## V2500-A5/D5 PROPULSION SYSTEMS SERVICE BULLETIN

#### Service Bulletin Revision 2

# V2500-ENG-72-0403

ENGINE – HP COMPRESSOR SHAFT – INTRODUCTION OF REVISED HP COMPRESSOR REAR SHAFT  
ASSEMBLY WITH NO.4 BEARING LOCATION COATING (A5 & D5 MODELS)

Rework of HP compressor rear shaft  
Fig 1

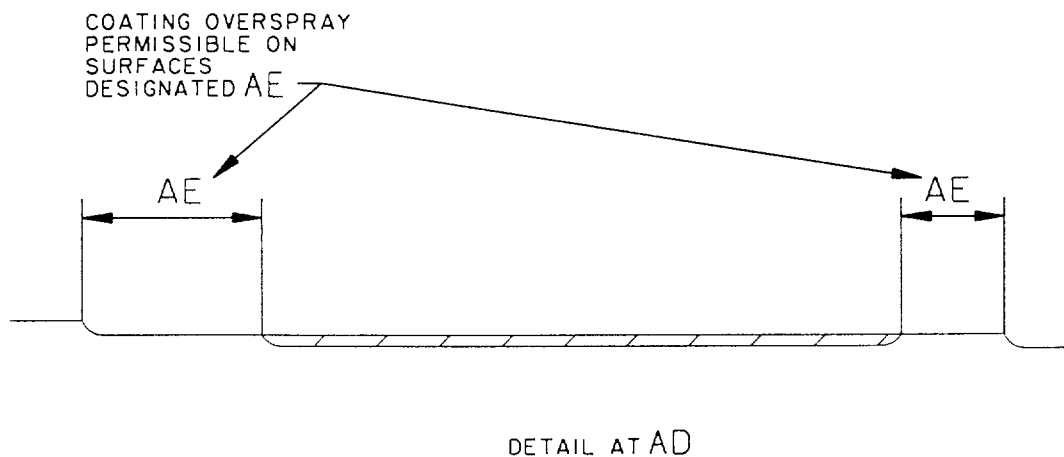
- (1) This Service Bulletin introduces an anti-frettage coating to the No.4 bearing location diameter of the HP compressor rear shaft assembly in order to minimise frettage and eliminate loss of fit between these two components.

- (i) A recess is machined into the diameter of the shaft at the No.4 bearing location to a controlled depth of 0,076mm to 0,152mm, with a width sufficient to ensure the final run-out of applied coating is well beyond the front and rear faces of the bearing.

(b) A tungsten carbide cobalt coating is applied to the recess and machine ground back in order to maintain the current No.4 bearing location diameter.

(2) Existing HP Compressor rear shaft assemblies may only be reworked providing that the No.4 Bearing diameter (identified as ZONE AB) has not been repaired with Chromium Plate in accordance with repair VRS6509 – see Figs 1 and 2.

(b) Install the HP compressor rear shaft assembly on to the fixture and set to turn correctly	Refer to Fig 1 and Fig 2. Use a dial test indicator and standard workshop equipment. Make sure that datums A, B and C are set to turn correctly

(c) Grind the HP compressor rear shaft assembly	Refer to Fig 1 and Fig 2. Refer to approved vendor process
(d) Remove burrs	Use standard workshop equipment

(10) Cold ferric chloride etch surface AB on the HP compressor rear shaft	Refer to Fig 1 and Fig 2. Refer to SPM TASK 70-11-39-300-503, SUBTASK 70-11-39-300-001. Use chemical cleaning equipment

(11) Visually examine surface AB on the HP compressor rear shaft	Refer to Fig1 and Fig 2. Use X10 binoculars. Indications of defects are not permitted
(12) Do a local penetrant crack test on surface AB of the HP compressor rear shaft	Refer to Fig 1 and Fig 2. Refer to SPM TASK 70-23-05-230-501. Use CoMat 06-022 fluorescent penterant, with penetrant crack test equipment. Cracks are not permitted

| (14) Apply the metal spray hard coating to surface AB on the HP compressor rear shaft | Refer to Fig 1 and Fig 2. Refer to vendor approved process |
